**INVER GROVE HEIGHTS
PLANNING COMMISSION AGENDA**

**Tuesday, October 3, 2017 – 7:00 p.m.
City Council Chambers - 8150 Barbara Avenue**

P L A N N I N G R E P O R T
CITY OF INVER GROVE HEIGHTS

**PLANNING REPORT
CITY OF INVER GROVE HEIGHTS**

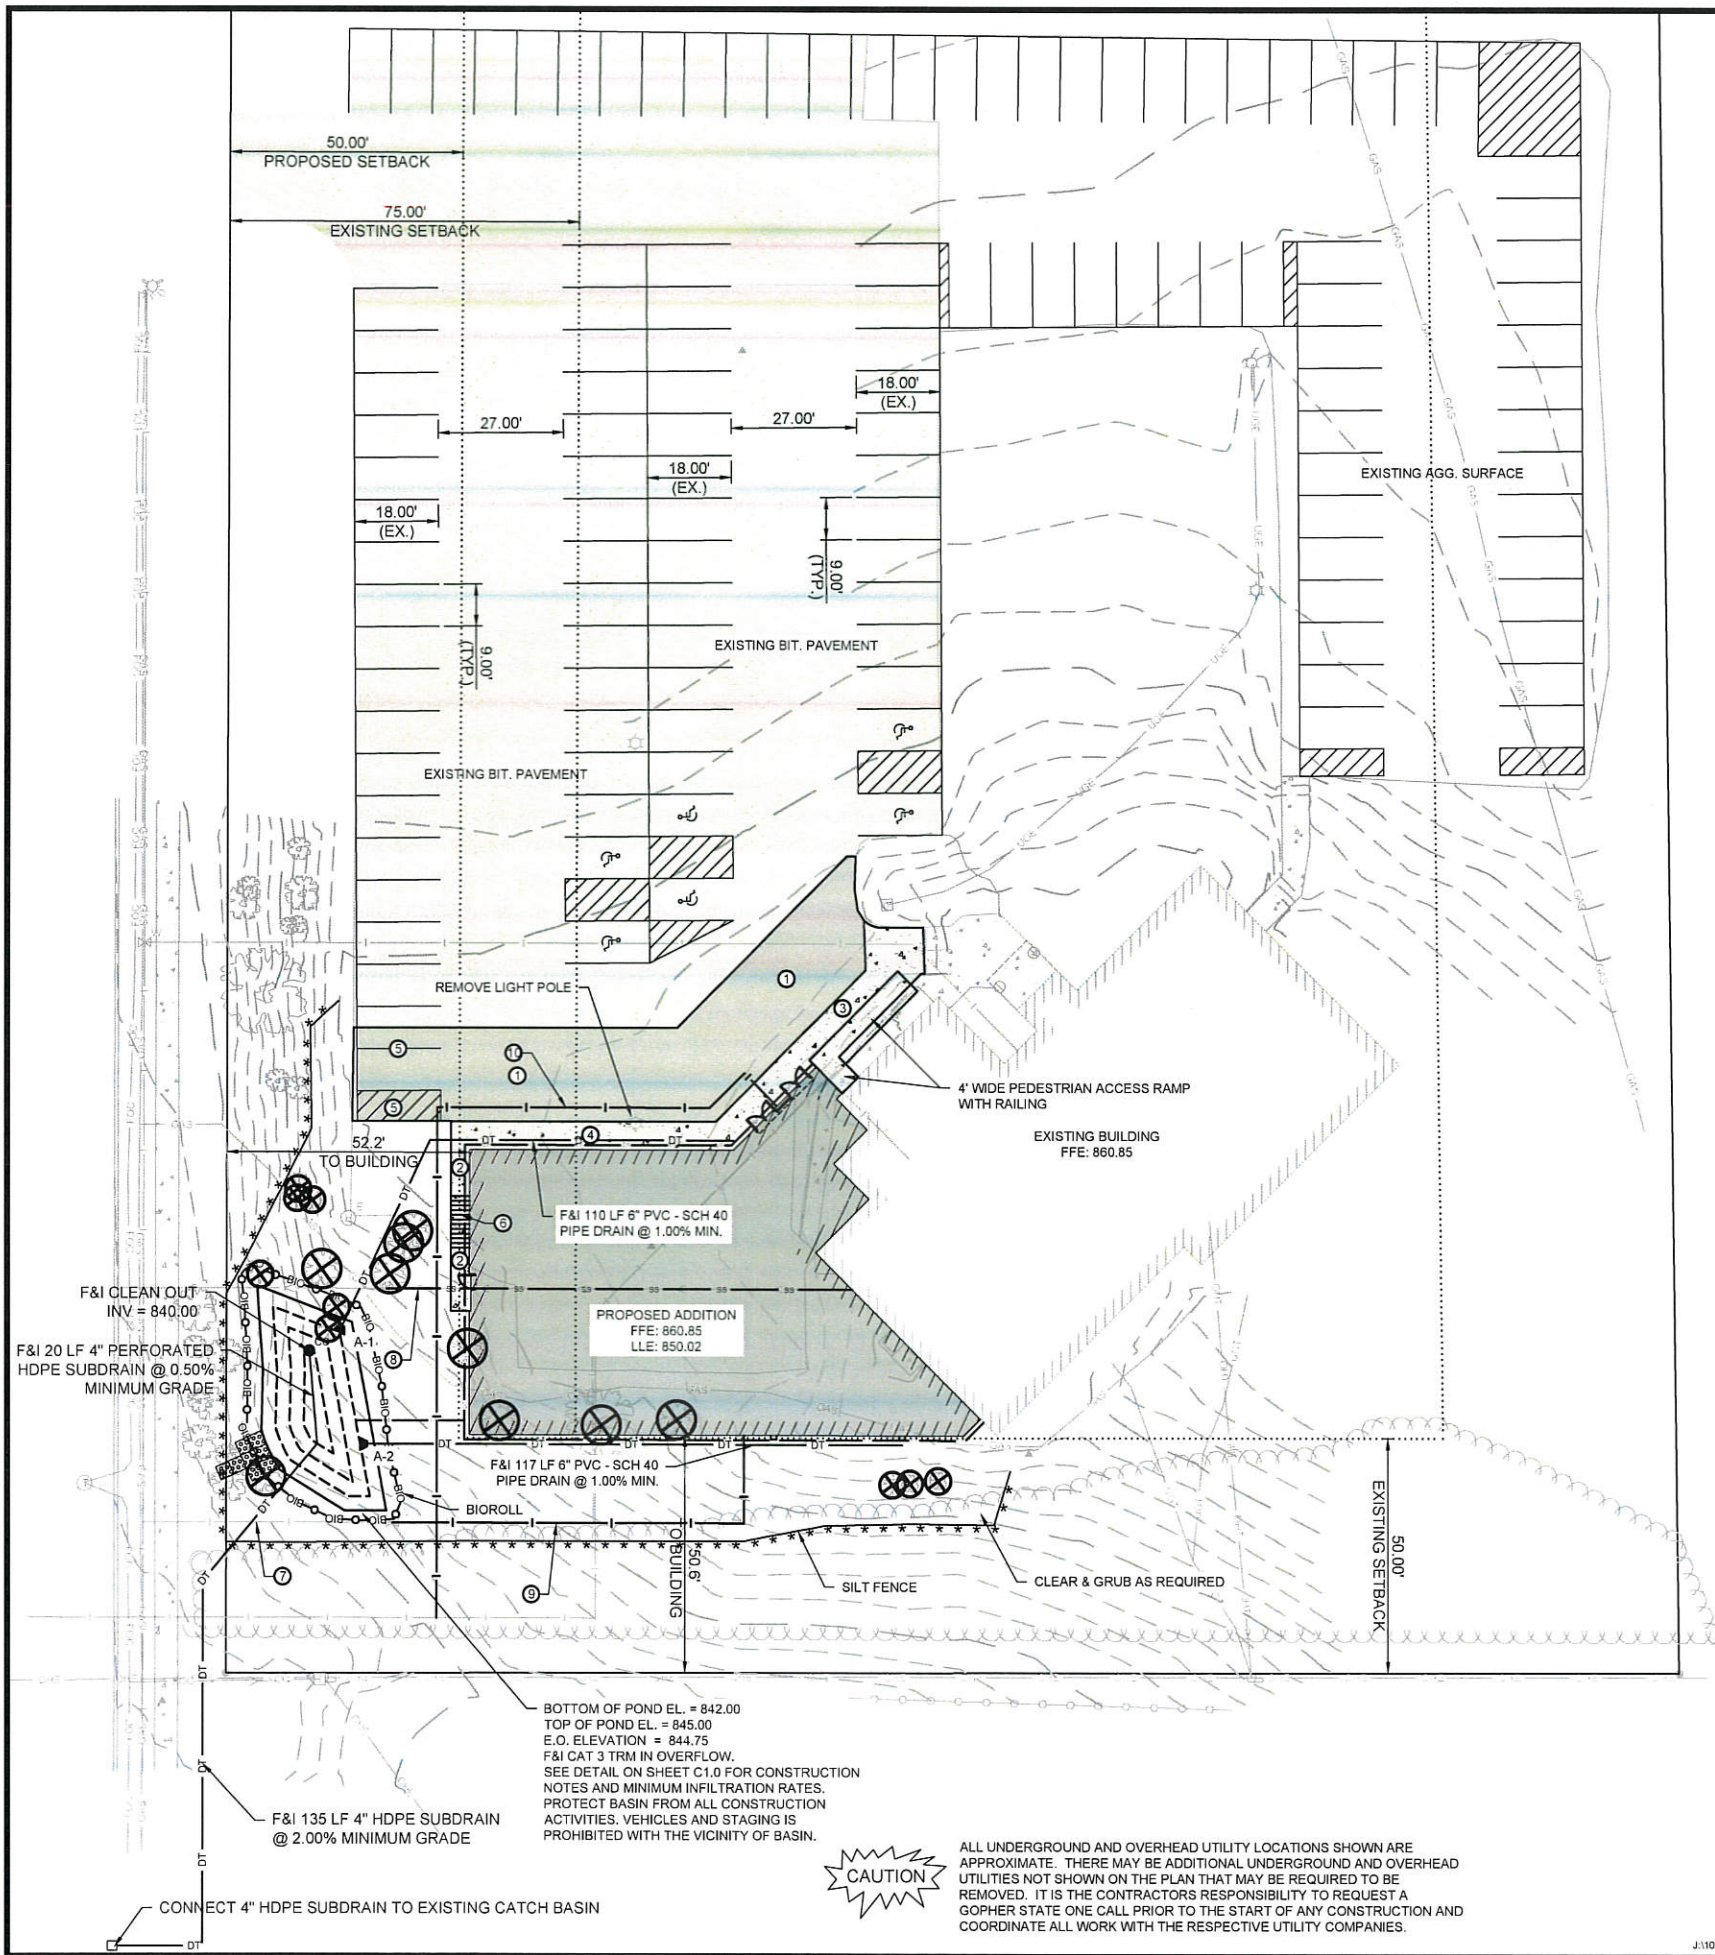
Setbacks. The P district requires building setbacks of 75 feet from Cahill and 50 feet when abutting residential properties. City Council approved a setback from Cahill of 50 feet. The proposed building location would be 50 feet from Cahill and 50 feet from the residential properties to the south. All building setback requirements have been met.

Building Coverage/Floor Area Ratio. The P district requires a maximum of 20% building coverage per lot. The proposed site plan provides for a total of 6.0% building coverage. The P district also has a floor to area ratio maximum of .25. The proposed building expansion would yield a ratio of .09. The impervious surface coverage requirement has been met.

Parking. The applicant expanded the parking lot earlier this year by adding 48 parking stalls in anticipation of the new addition. The site plan indicates the sanctuary would have 333 seats. Based on the ordinance requirement of one space per 3.5 seats, a total of 96 parking spaces are required. There are 124 existing stalls including the new parking addition. Based on requirements, the site complies with parking standards.

Site Plan	dated 9/28/17
Grading Plan	dated 9/28/17
Elevation Plan	dated 6/12/17
 - 2. All roof top and ground mounted equipment shall be screened 100% from view of the public. Details of all equipment must be shown on the building permit plans.

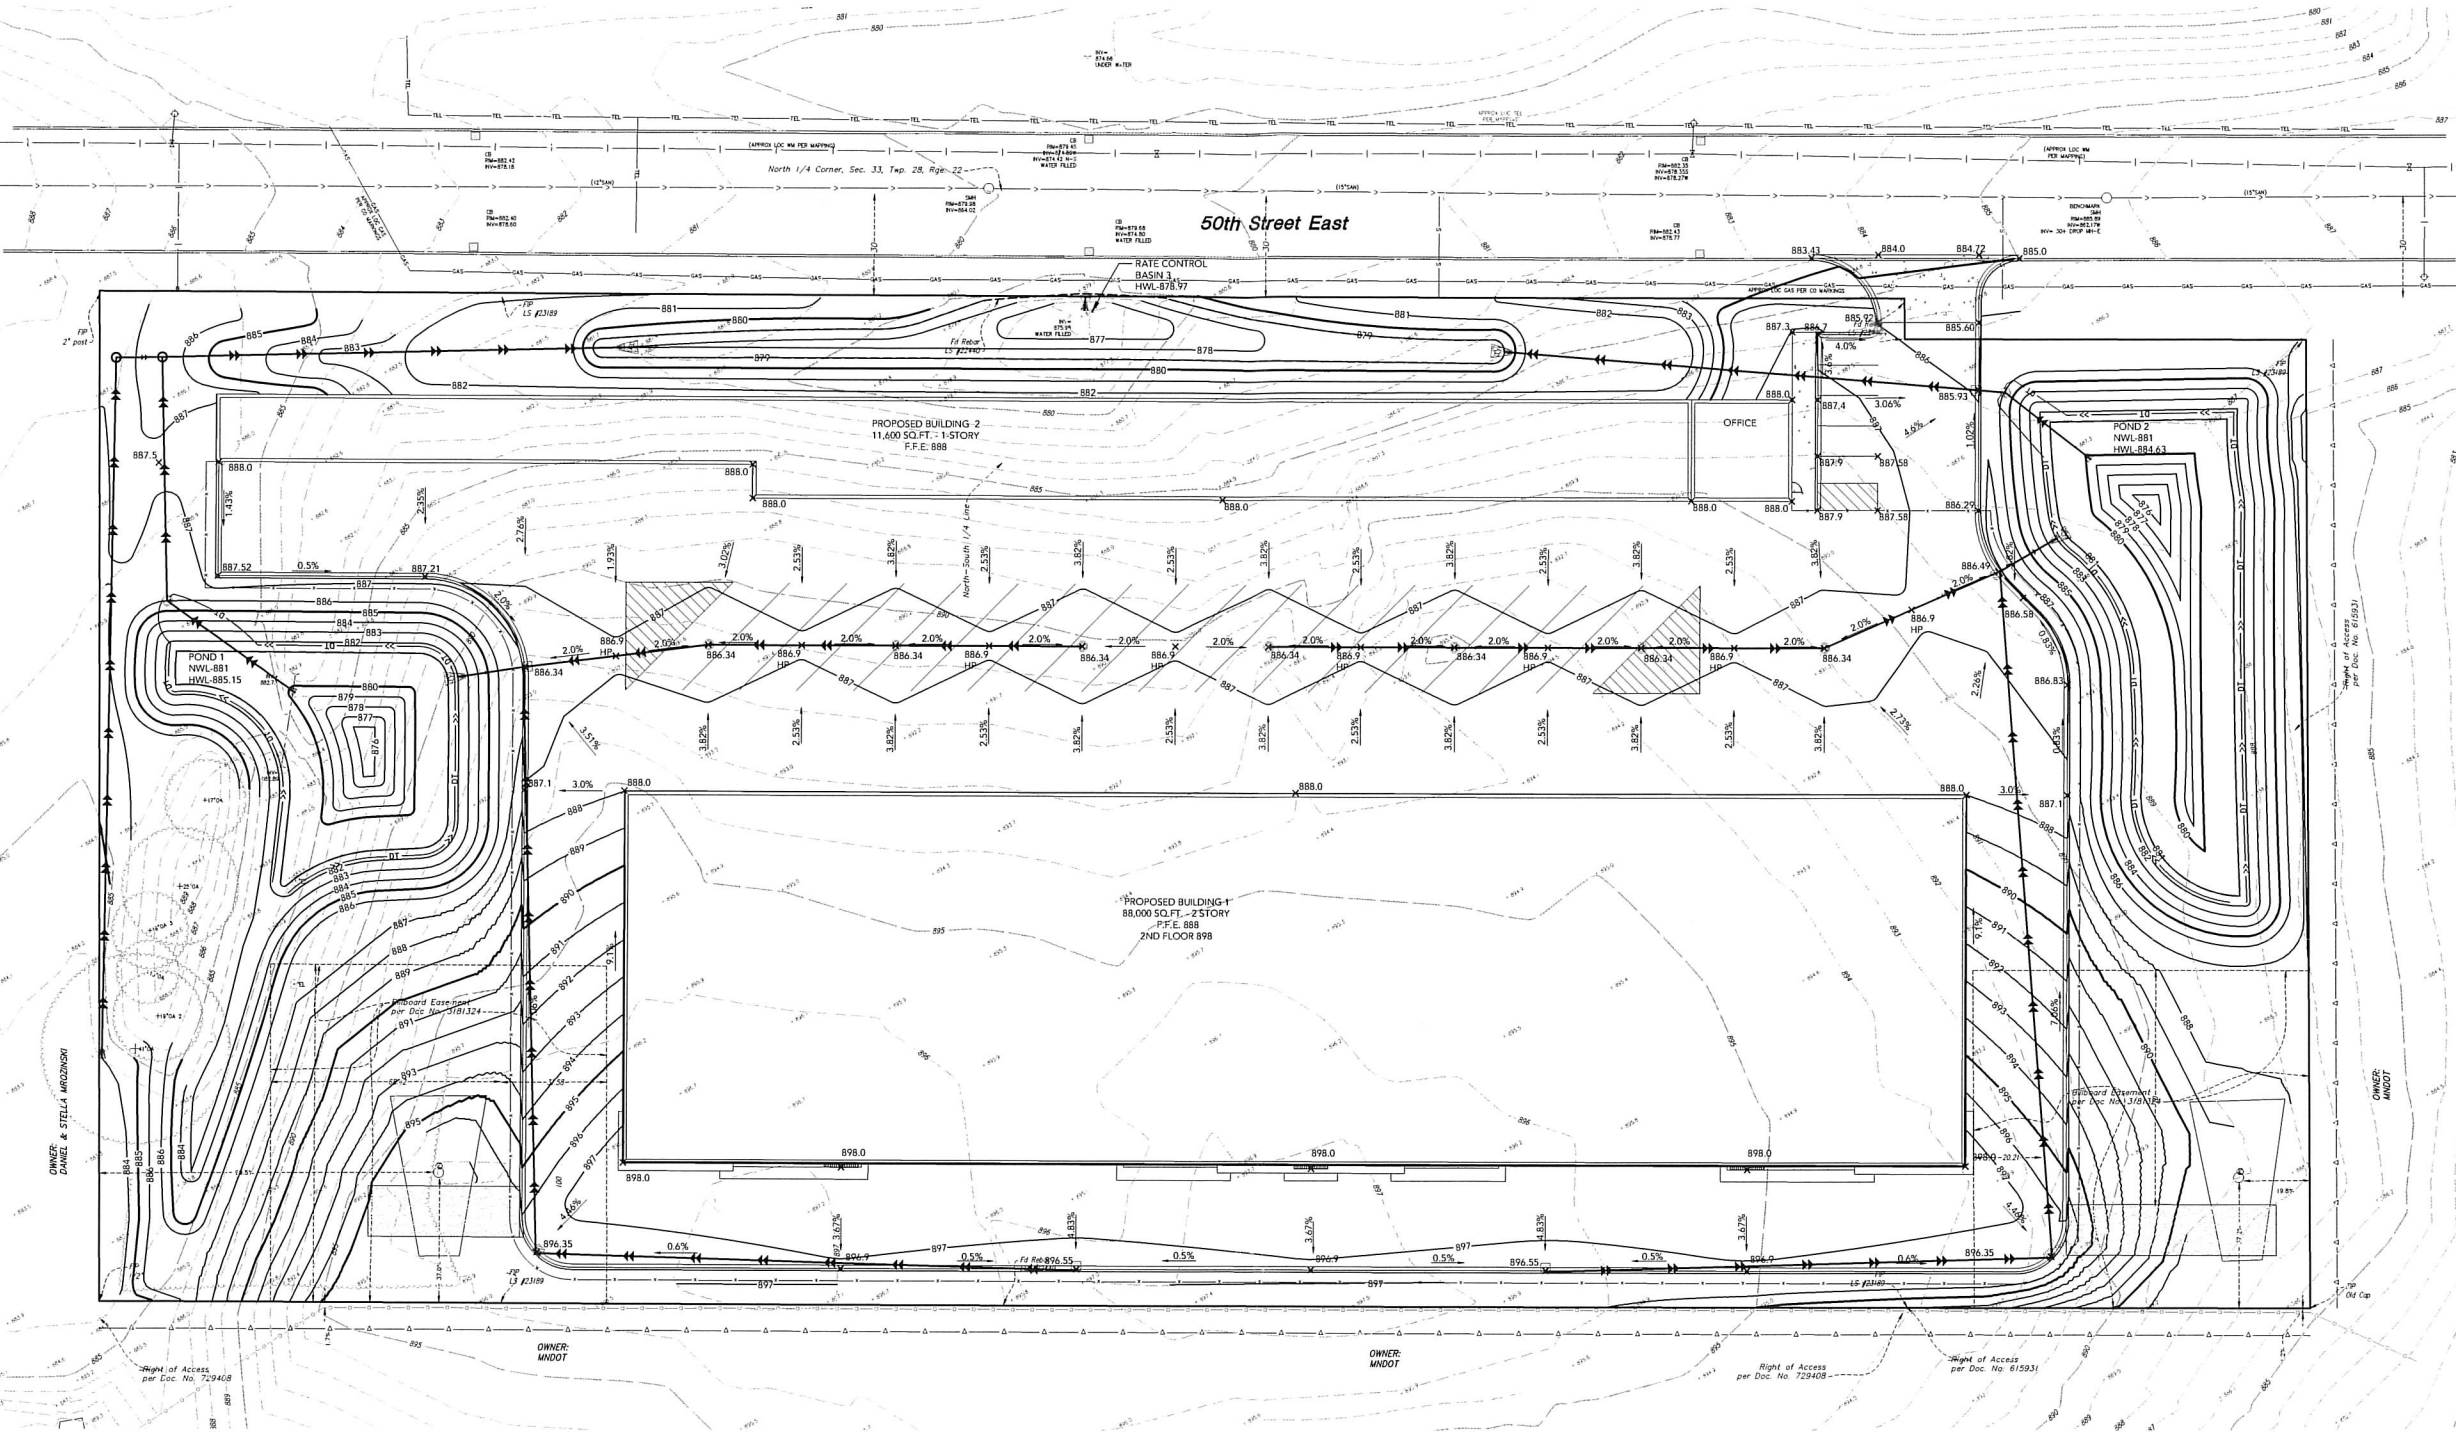
Screening/Landscaping. The submitted landscape plan shows a mixture of trees and shrubs. The zoning code requires the equivalent of 100 trees to be planted based on one tree per 1,000 square feet of building gross floor area. The submitted landscape plan shows the equivalent 70 trees that are a combination of over-story, ornamental, and shrub plantings. A variance from the landscaping requirements is discussed later in the report.

44 trees without increasing the impervious surface or footprint of improvements to the site. Staff believes the applicant is proposing to use the property in a reasonable manner as they are not able to install landscaping in the sign easement areas, there is challenging topography along the westerly border and there are two infiltration basins on the site which all limit the location of plantings.

Additionally, the site is limited to the type and location of trees along the southern property line. Staff believes there is room to plant ornamental trees along the south lot line without creating site line issues and recommends replacing the proposed shrubs with ornamental trees.

2. The landscaping plan shall be modified to include 20 ornamental trees along the south property line.
3. Prior to issuance of building permits, the final grading, drainage and erosion control, and utility plans shall be approved by the City Engineer.
4. The applicant shall meet all the conditions outlined in the City Engineers review letters and subsequent correspondence. Prior to commencement of any grading, the final grading, drainage and erosion control, and utility plans shall be approved by the City Engineer.
